FD1 HV EW Design Review

Thomas Kutter
for the LSU team

EDMS 2633165 Comments

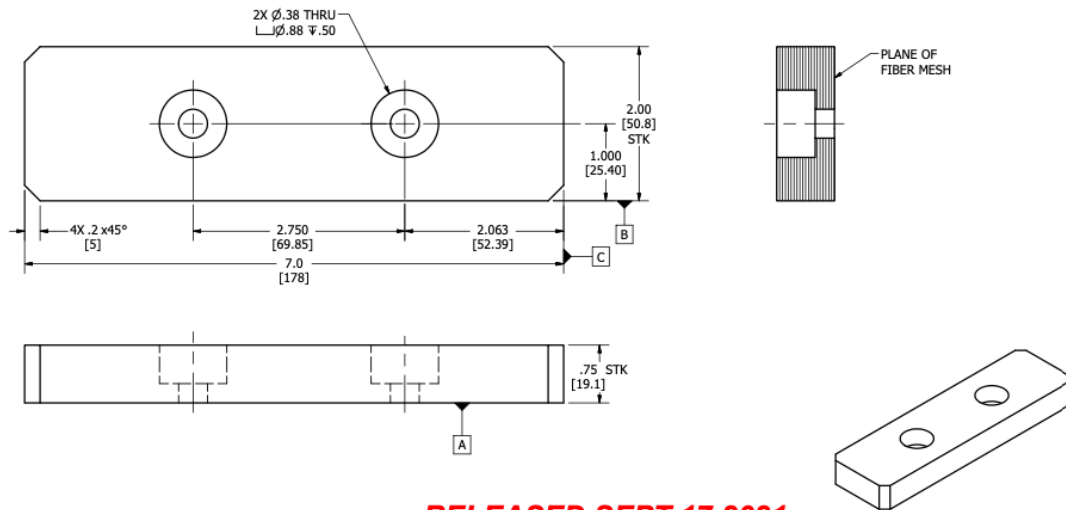
Some duplication of drawings

Action item: Remove duplicates and super-seeded drawing versions

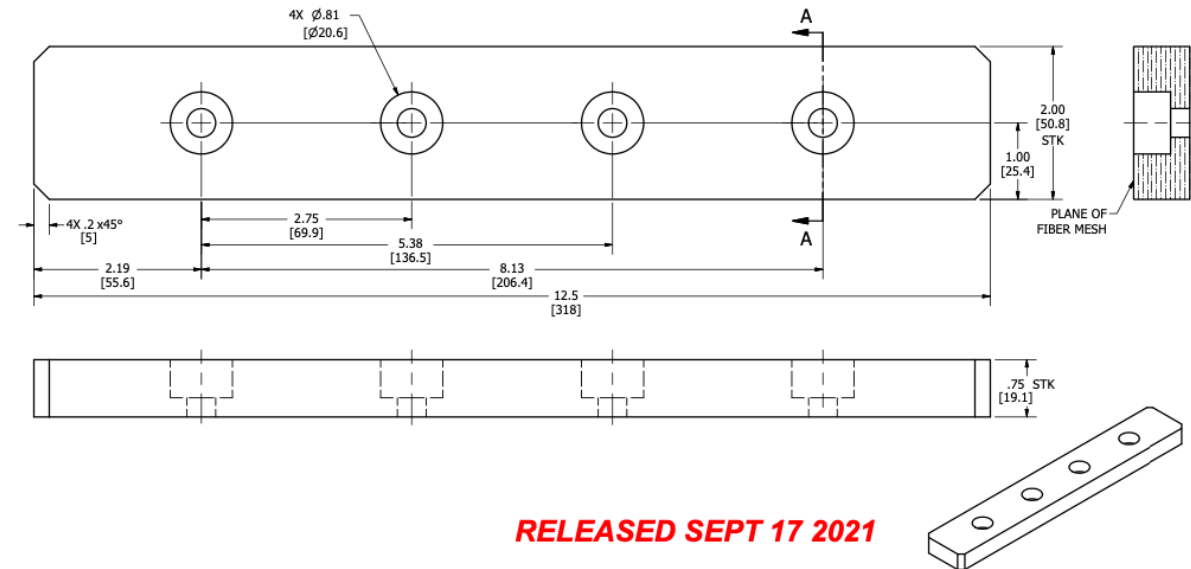
DFD-19-2027/2031 for the endwall-APA restraints contains a small built in asymmetry

- Left hole center to edge = 2.187"
- Right hole center to edge = 2.063"

Action item: This should be corrected so that the restraints are symmetric

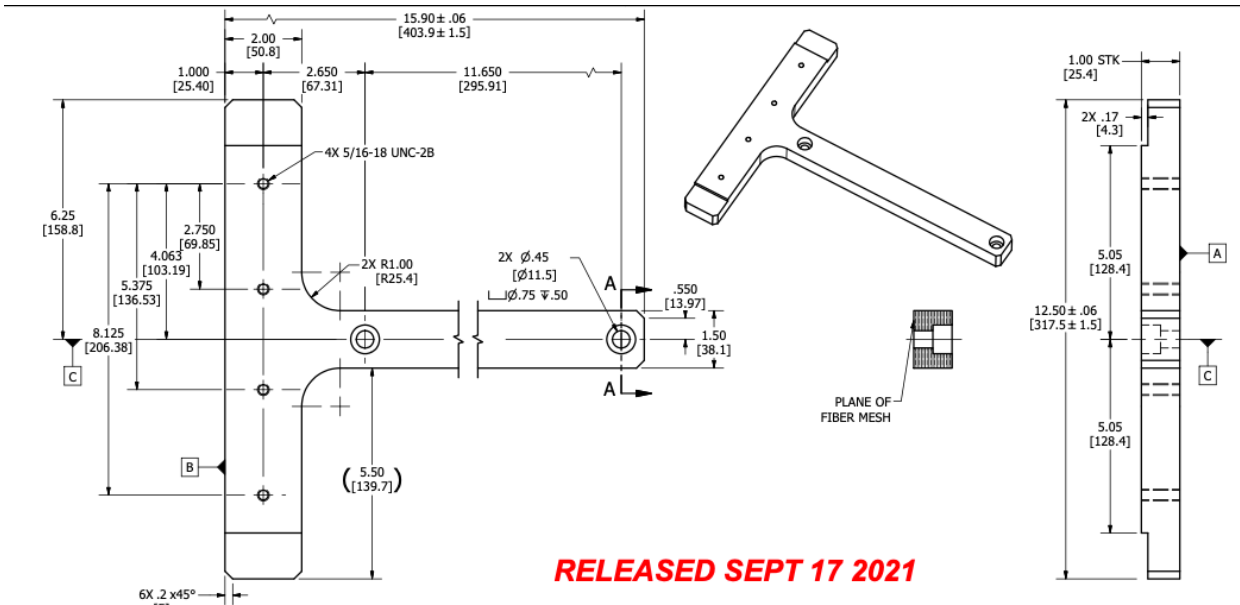
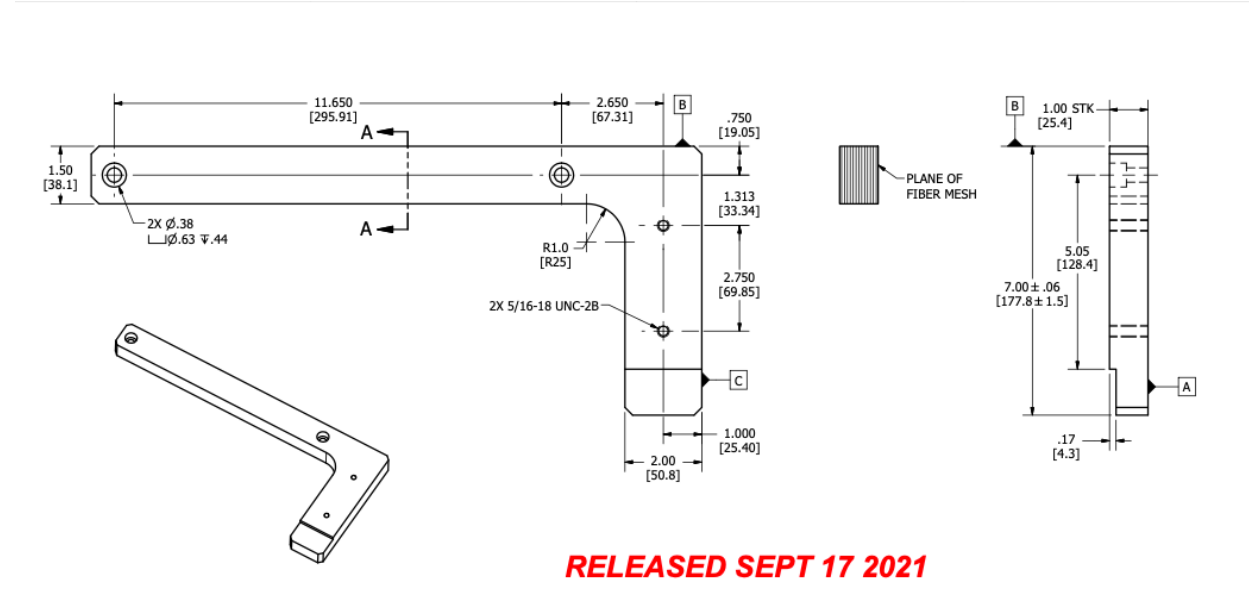
DFD-19-2032/2034: Inconsistent tolerances on the endwall-APA/CPA restraints

- Tolerance on length is +/- 0.1"
- Tolerance on short arm is +/- 0.06"

Action item: This should be corrected so the reflected tolerances are consistent

PD2-22-5182/5186:

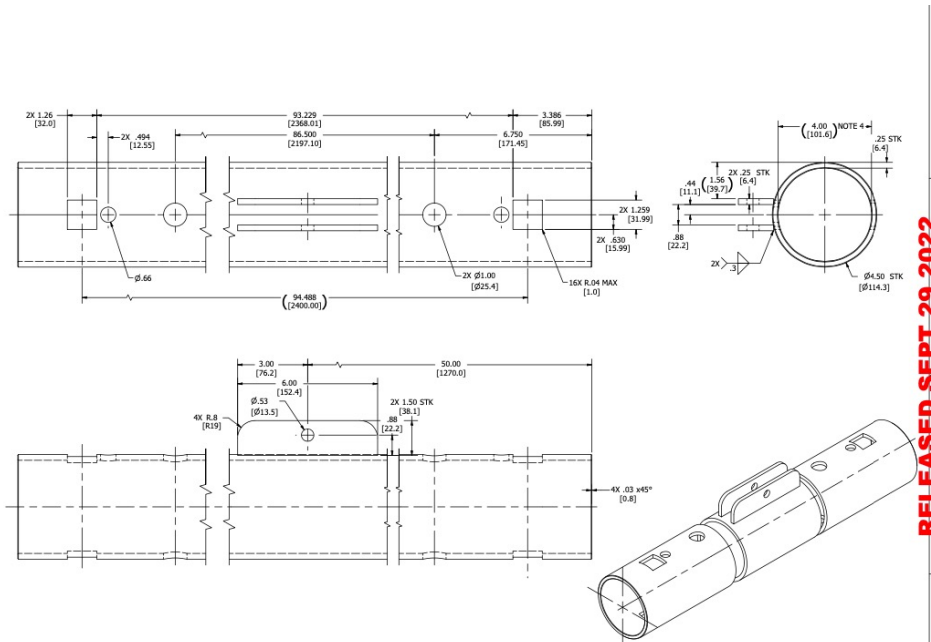
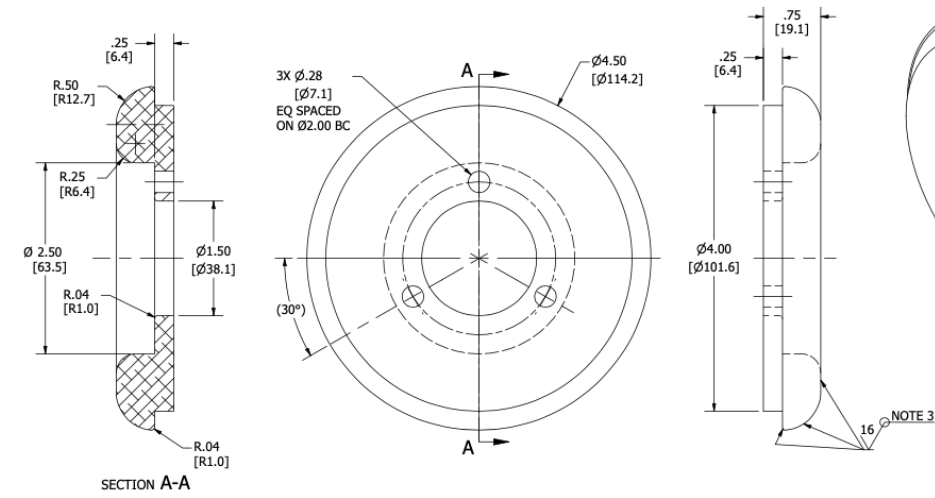
The inner diameter of the end caps does not always fit on the end of the hanger tube (PD2-22-5182)

Action item 1: reduce the inner diameter of endcaps by ~10/1000"

Action item 2: rounding of edges of PD2-22-5186 on side facing DFD-22-5182of

DFD-22-5411:

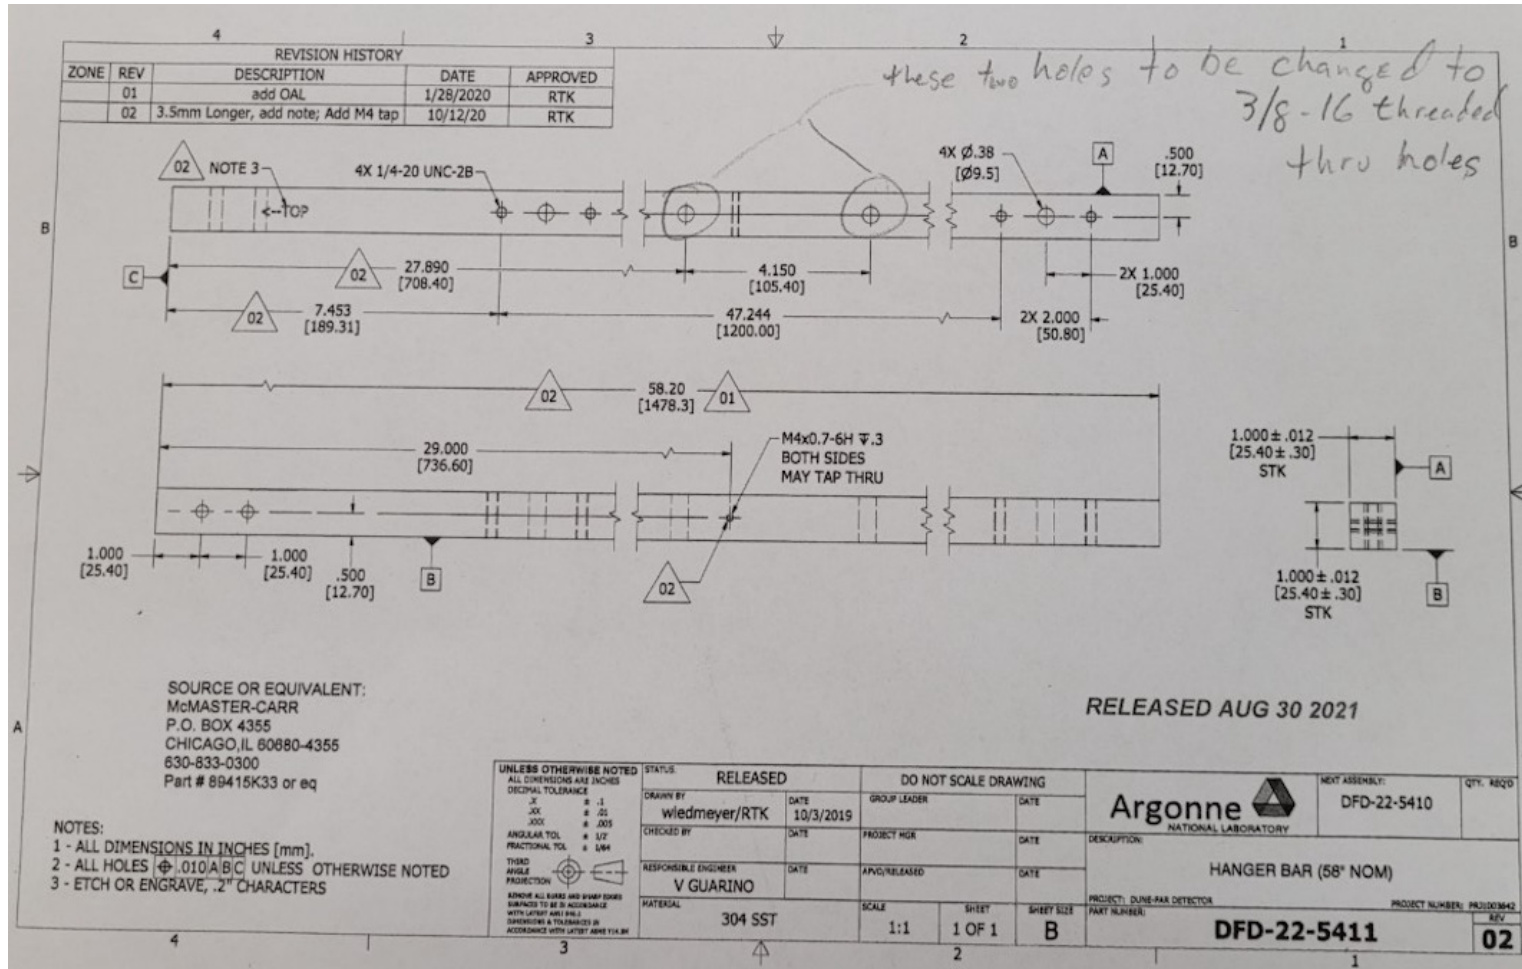
Threading not shown

Action item: indicate 3/8-16 threaded through holes

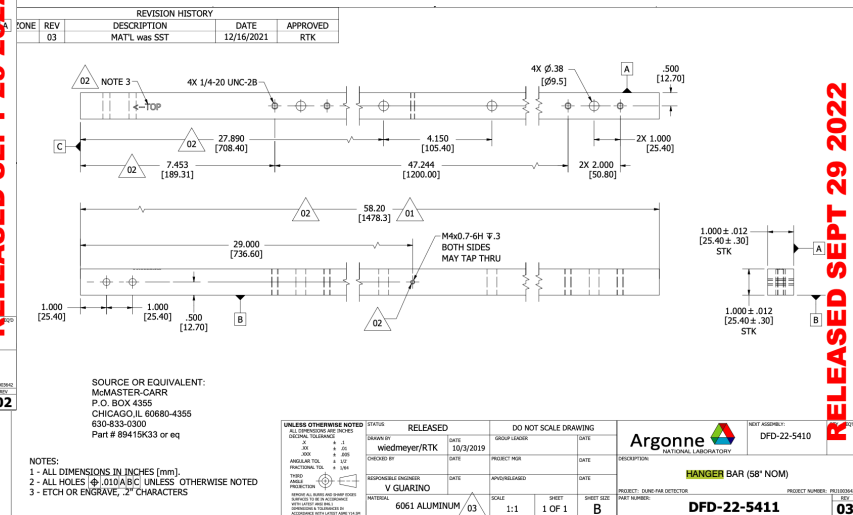
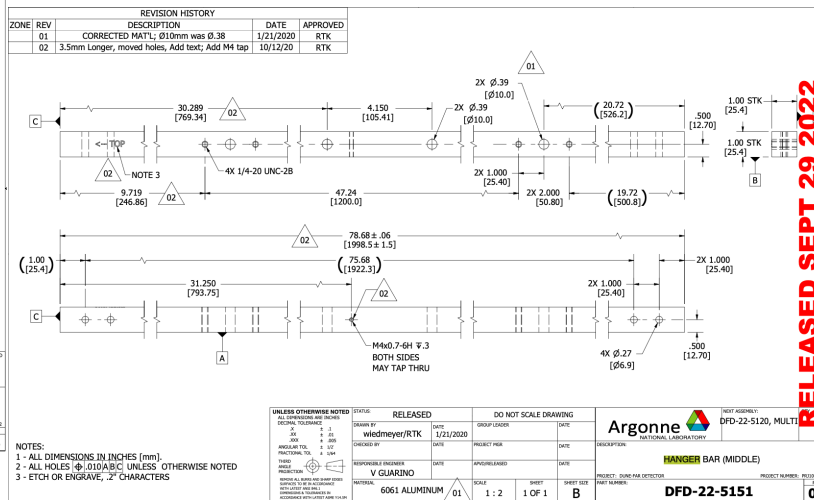
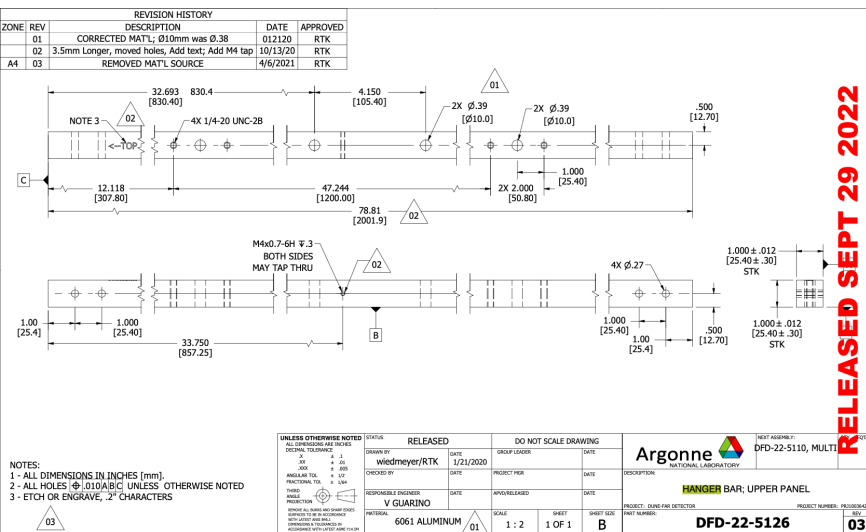
DFD-22-5126/5151/5411: add chamfer on top side to facilitate insertion to C-brackets
Action item: chamfer (1/8") top of hanger bars for middle and bottom panels.

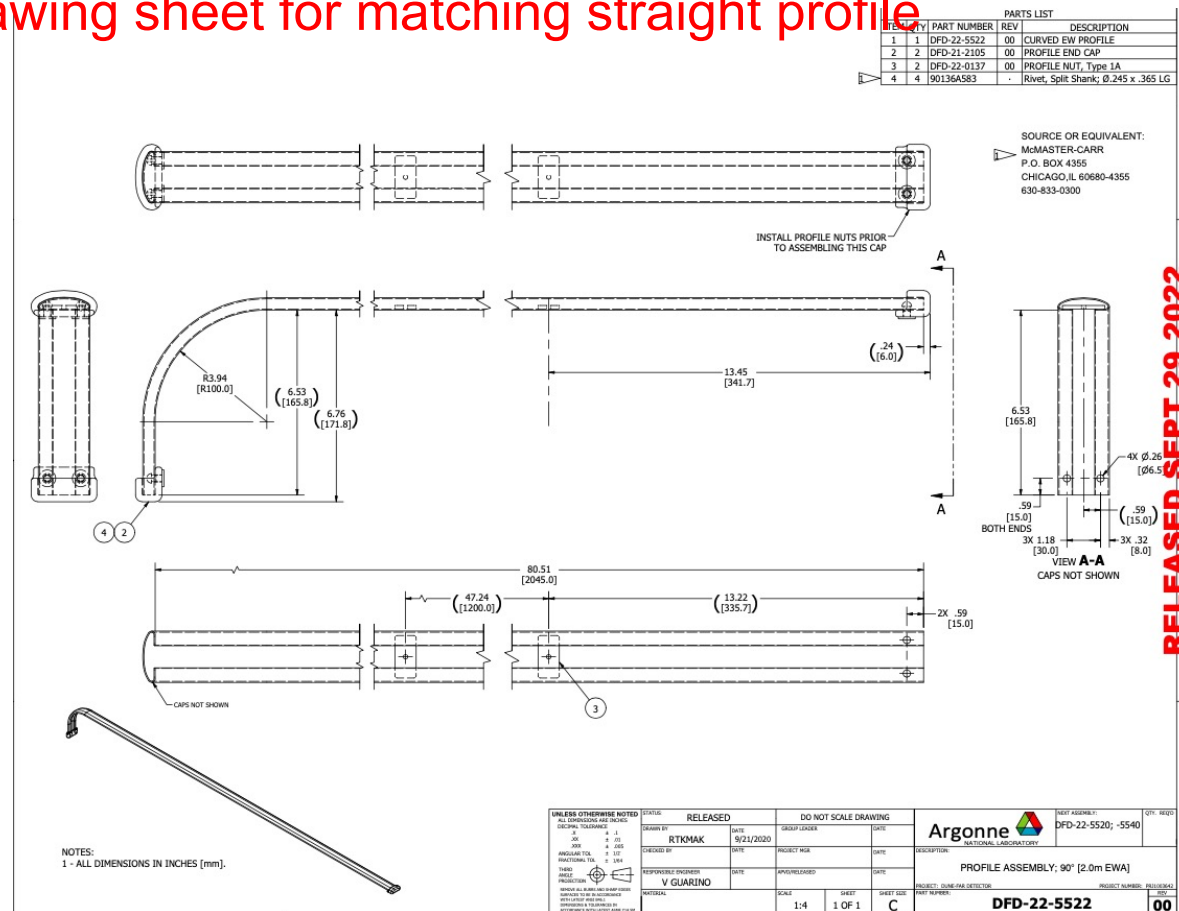
DFD-22-5522: When cutting profiles to be bent, one must take into account the compression of the material during the bend. Will lose 5.03 mm in length on the long straight portion of the profiles.

Action item: Need to account for and explicitly show profile length to be cut ; add drawing sheet for matching straight profile

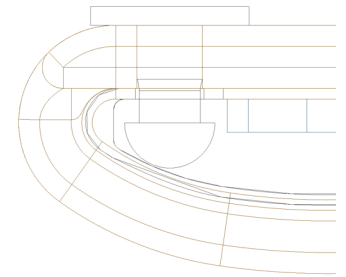
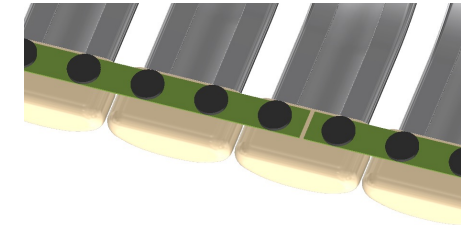
A thin G10 strip should be attached to the end caps of bent profiles to ensure the profiles align properly

Action item: Make and post corresponding drawing

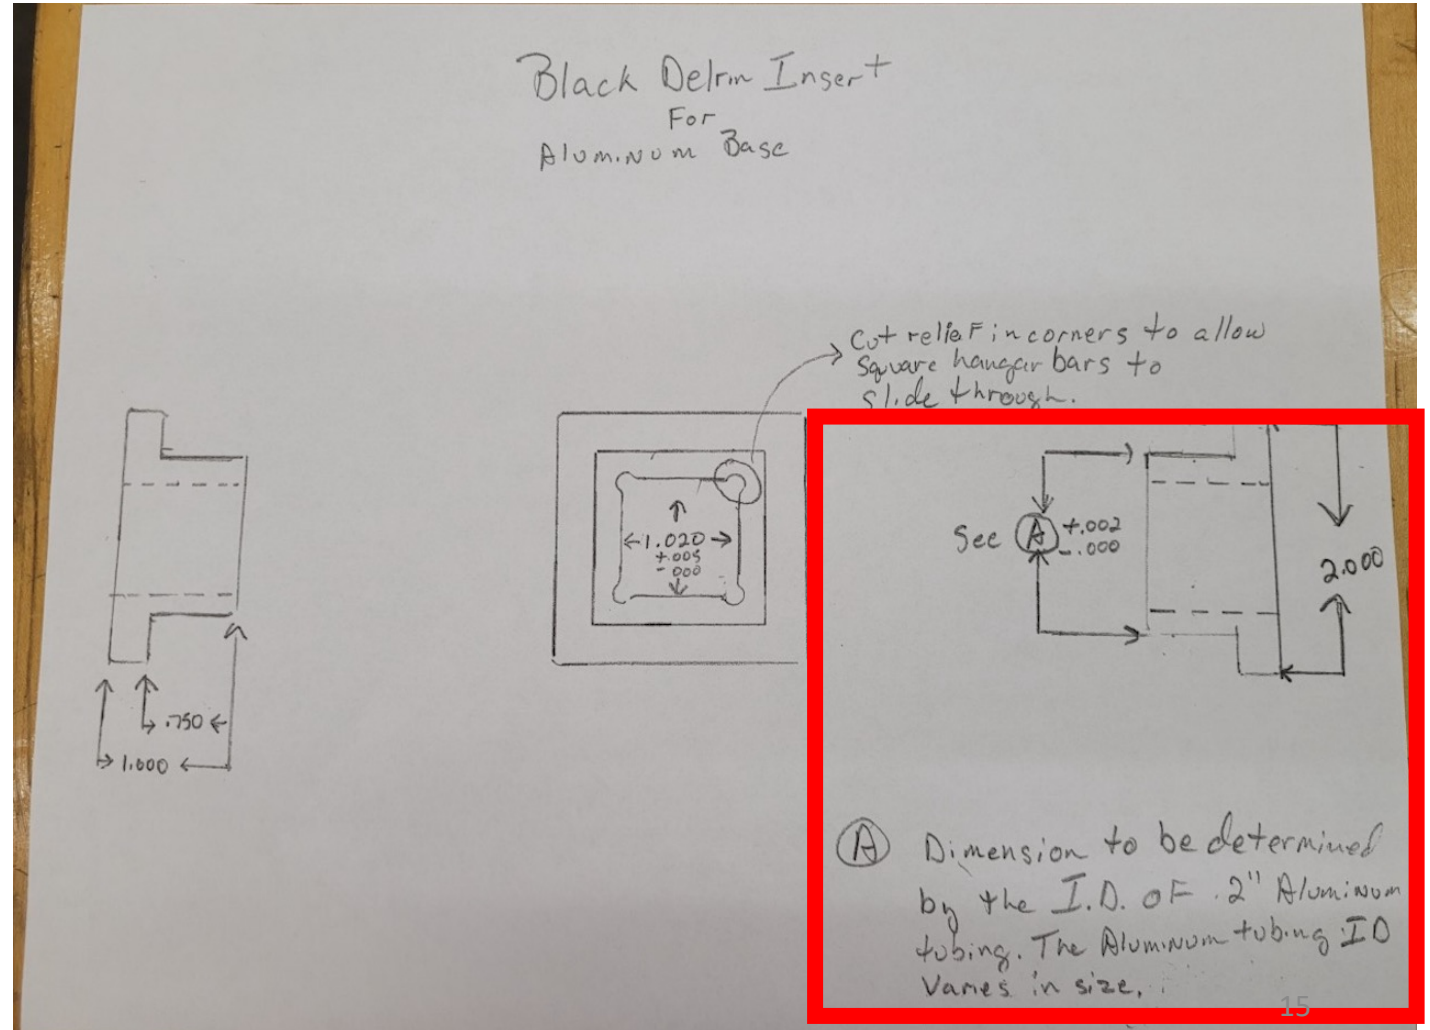
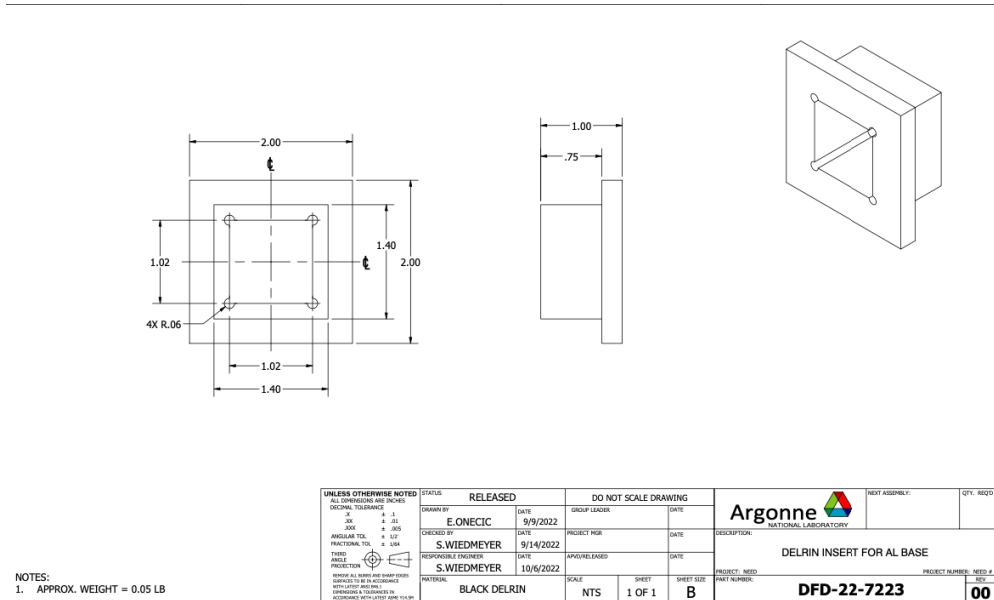
Drawings live in many (qty: 40 !) individual pdf files

Action item: bundle pdf drawings for tools into single file

DESCRIPTION: FC EW ALIGNMENT BRACKET LEFT

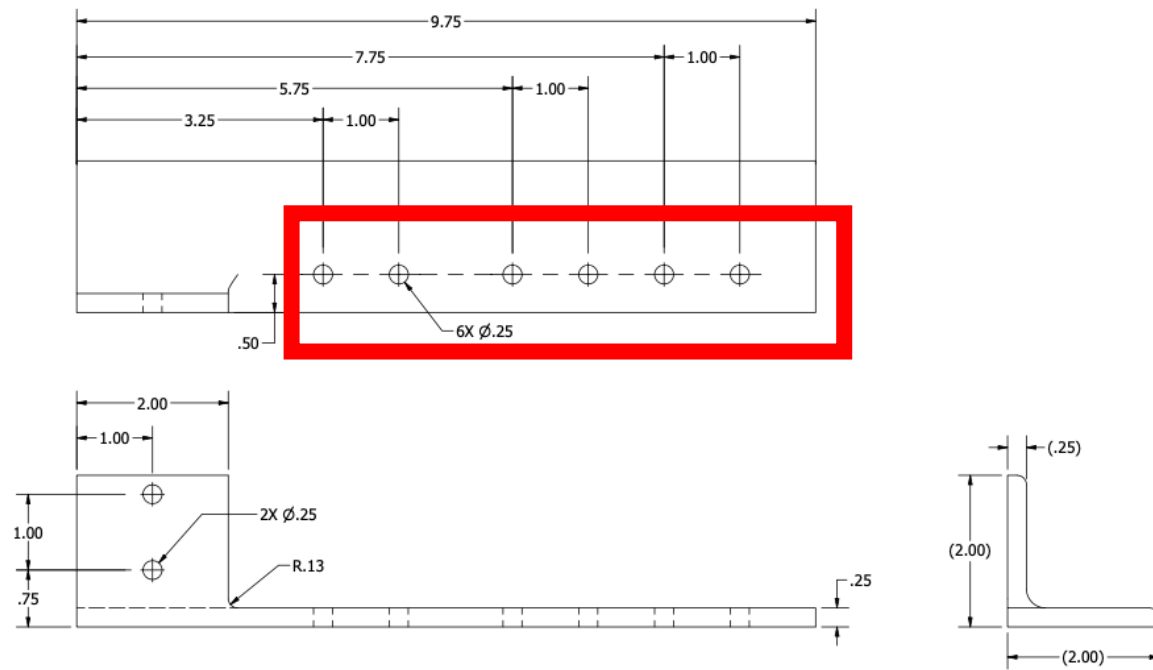
DFD-22-7213: The L-bracket holes used for attaching the alignment bar should have the 3 sets of holes labeled to avoid any confusion during assembly

Action item: Label hole sets
